## Product Change Notification

**PCN#:** 390

**Change Title:** Product Specification Change

Model Number	Part Number
FX216C	617C-Frequency-xxxxx

## FX216C Dimensions Effective 06/07/2012

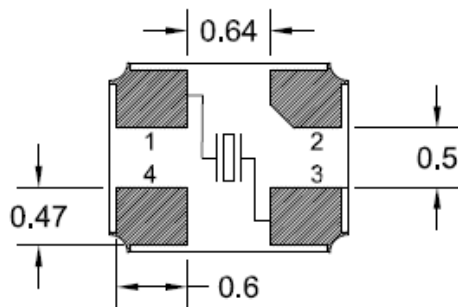
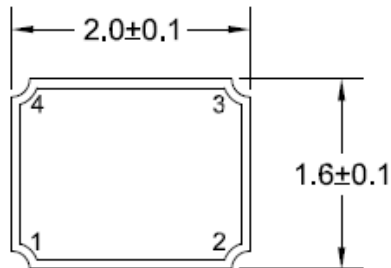
Height change from 0.4mm Max to 0.45mm Max for frequencies from 24.000 MHz to 25.999999 MHz.  
The height for frequencies 26.000 MHz and above remains 0.4mm Max.  
See attached dimensional drawing with new height dimensions.
